TOTALFLOW Technical Bulletin 89

AP location parameter change required when using code BYS version AMU

Totalflow Technical Bulletin

Version 1.1, Revision AC (22 May 2001)

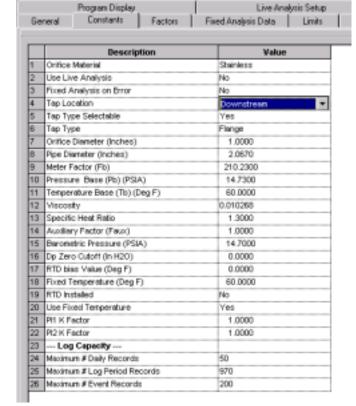
The AP tap location parameter must be programmed for "**upstream**" when installing any of the "B" versions of the AMU. This parameter is settable using ABB's PCCU32 software, laptop software, or Husky FS2. This parameter allows the software to compensate the AGA equation based on the AP's physical location. Failing to make this change could cause a slight error in the computed volumes. Below is screen shot using PCCU32 software. (The parameter is located within PCCU32's Entry mode constants tab)

BYS, BYC, and BZC require the FCU's tap location setting to be "Upstream" for proper volume calculations.
